Urgent Field Safety Notice

Subject: Liko® Multirall™ 200 Q-link strap lock replacement

FSCA-identifier: MOD1322

Type of action: Device Modification

Correct vs incorrect attachment of Q-link strap lock of Multirall 200 to S65 rail carriage hook

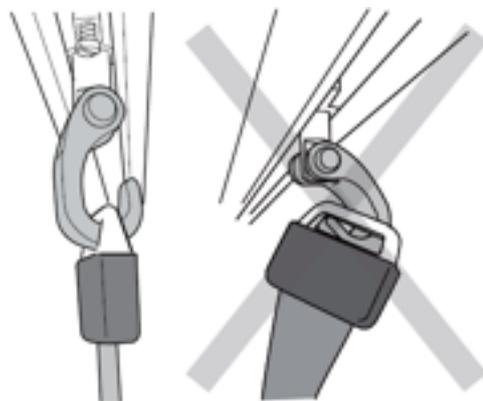
Hillrom continues to receive complaints of incidents where the Multirall Q-link strap lock has not been correctly attached to the S65 rail carriage hook by user (illustrations below). This may lead to the Multirall lift becoming detached from the rail system, potentially resulting in the fall of both the lift motor and the patient. An advisory notice, with reinforcement of the instructions for use was shared with all customers of the Multirall 200 in 2017 (MOD1267), and since then additional complaints of serious incidents due to this use error have been received by Hillrom.

Hillrom will be replacing the Q-link on Multiralls to Q-link II to improve ease of use and mitigate potential risk to patient or caregiver.

The Q-link 2 strap lock design

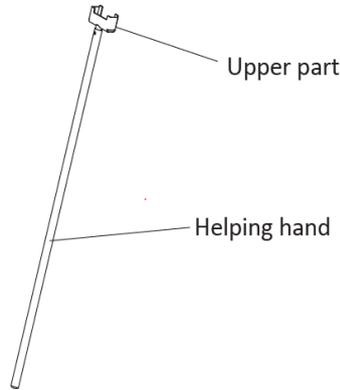
The Q-link II strap lock (illustration below) was introduced on the Multirall overhead lift to resolve ease of use issues with the application of the Q-link strap lock to the S65 carriage

hook, particularly while applying the Q-link strap lock from the ground level with the Extension arm accessory (illustration below). The Q-link II has a larger opening which allows for better visibility while attaching the hook and the rolling feature of the Q-link II strap lock makes it easier to apply on the S65 rail carriage hook.
